MEETING MINUTES

Architectural Review Board

Wednesday, April 23, 2025

N. High Street Renovations

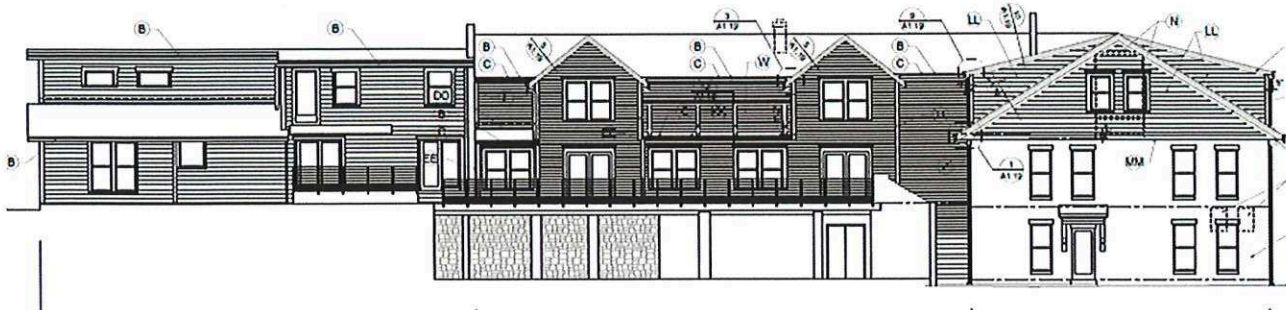
Ms. Holt referenced the above rendering of 72/84 North High Street to detail proposed renovations. The left side has new windows and doors and will retain the stone. The center portion has the signature feature box bay windows that are treated uniquely from the rest of that portion of the building. There are single hung windows, special trim detail and drop siding that will match the siding found underneath the plywood skin. This will be clad in 4-inch reveal lap siding. On the right

side, 7" horizontal siding will be used. There are new windows and doors. The gable and box bay detail has been simplified, which is appropriate for this newer section of the building. A rendering from the river was shown for reference.
